Document Information			
Document #	0201741/02-RCA-0272	Revision	
Title	QUARTERLY NOTIFICATION OF CLASS 1 MODIFICATIONS TO THE HANFORD FACILITY RESOURCE CONSERVATION AND RECOVERY ACT (RCRA) PERMIT, DANGEROUS WASTE PORTION (QUARTER ENDING MARCH 31, 2002 - PERMIT CONDITION I.C.3)		
Date	04/09/2002		
Originator	J. HEBDON, R. H. GURSKE, R. D. (ROBY) <i>ENG E</i>	Originator Co.	DOE, FH, PNNL
Recipient	L. E. RUUD	Recipient Co.	DOEC
References			
Keywords			
Projects			
Other Information

FMP-CS (Facility Modification Package - Coversheet) (Block 17, 18, 22)*

1. Mod Title: Change to ECN-664331			
2. USQ Required? USQ # _____ N/A _____ CX # _____ N/A _____		3. Assigned Lead Engineer: H.L. Roach	4. Design Authority: S.T. Willett
5. Project No./Work Package No.: EL-00-00712/M	6. Area 200E	7. Building 2025E	8. System No.: 60J
9. Related FMPs/Changes:	10. Incorporates ECN/DCNs:	11. Contract Mod. No.:	12. Change Proposal No.:
13. Lead Engineering Discipline:	14. Affected Engineering Disciplines:

15. Change Description (description and reason for requested change):
 Drain pipe upstream of valve 60J-107 needs to be capped. A detail is provided for capping this drain with applicable changes to th

R / Dwg H-2-99048	Sh 9	Rev 2	Prepared By K HALE	Check d By	ECN N 664551	Page 5
----------------------	---------	----------	-----------------------	------------	-----------------	-----------

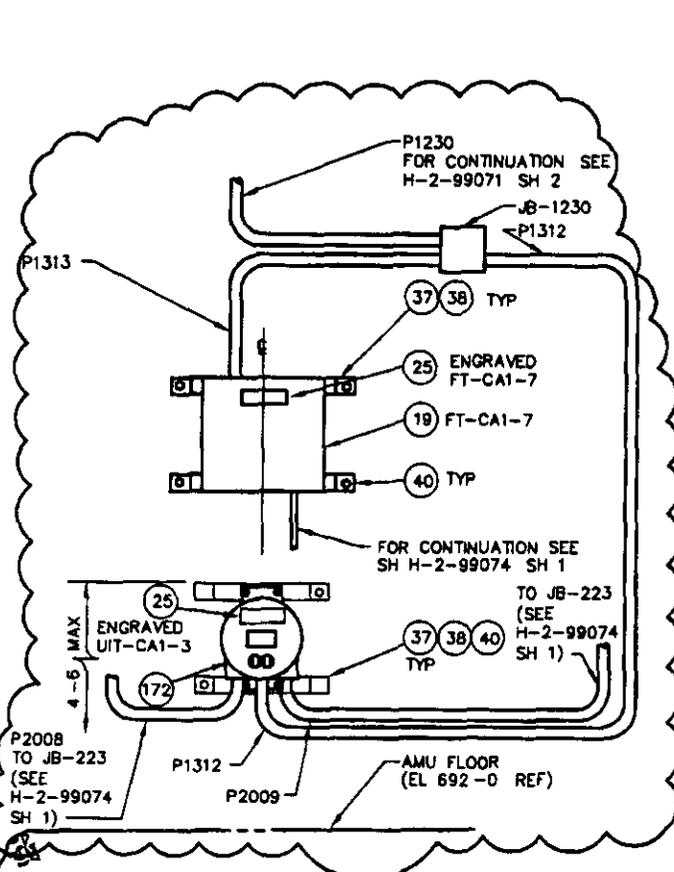
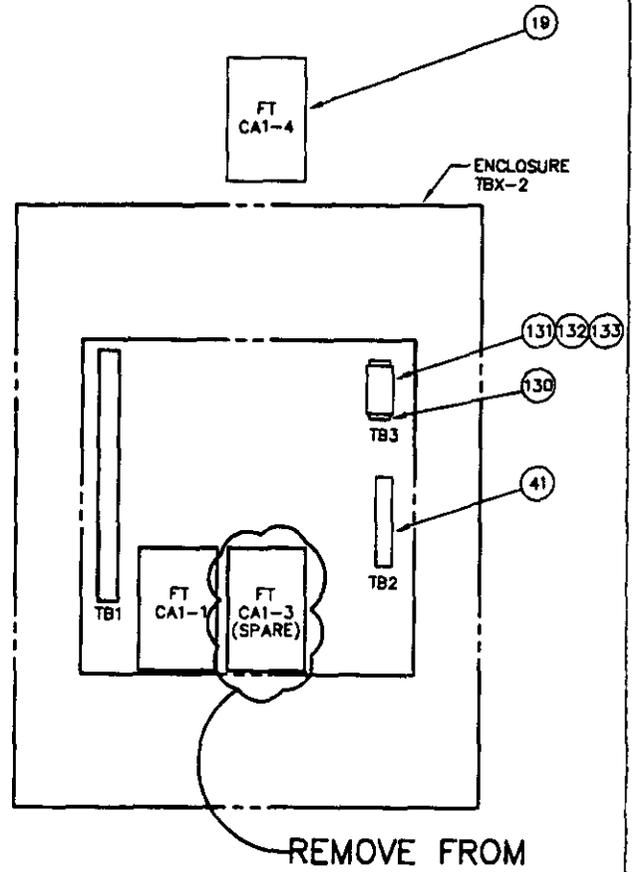
ADD NEW FLOW TRANSMITTER AND NAMETAG (LOCATE NEW TRANSMITTER BELOW EXST FLOW TRANSMITTER) INTERCEPT EXST P1230 AS SHOWN
EXST FT-CA1-3 IS TO BE REMOVED CONDUCTORS TO BE SPARE

ZONE B/4

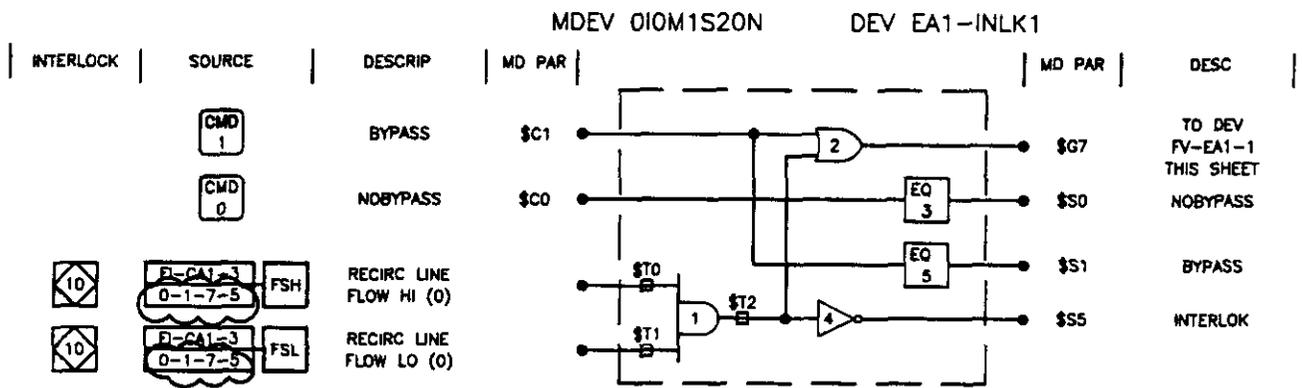
REVISE PCM MULTIPLIXER BOARD AND POINT ADDRESSES ON LOGIC DIAGRAM

300 Area Waste Acid Treatment System Substructure Soil Contamination Location - Area 2

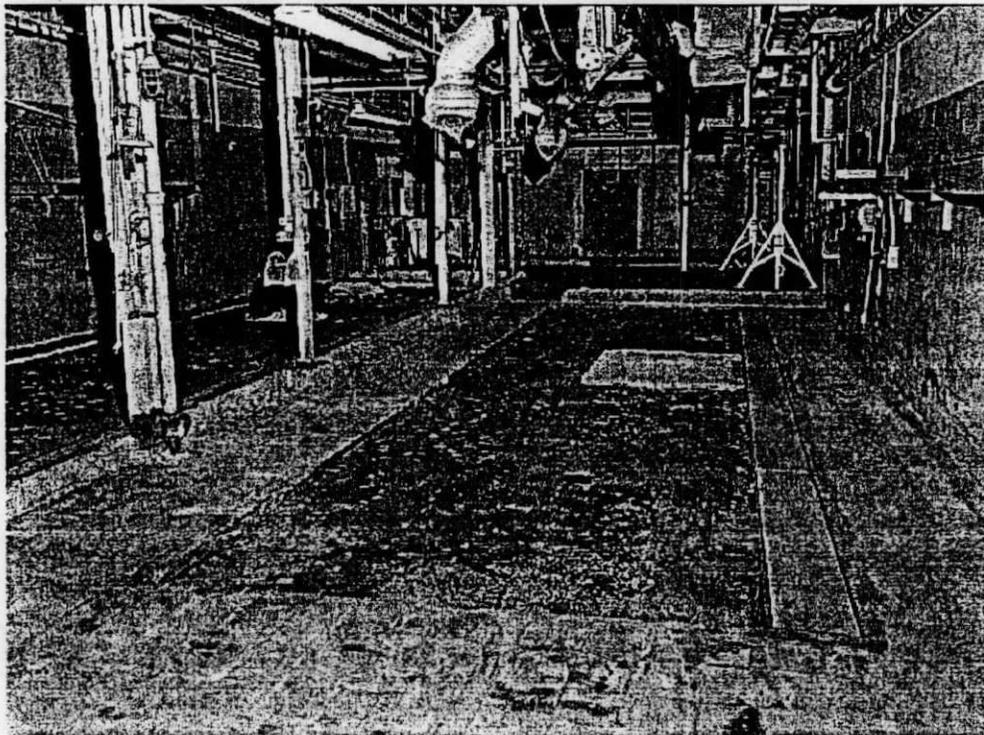
300 Area WATS Part A, Form 3, Photographs: Add the following photograph.
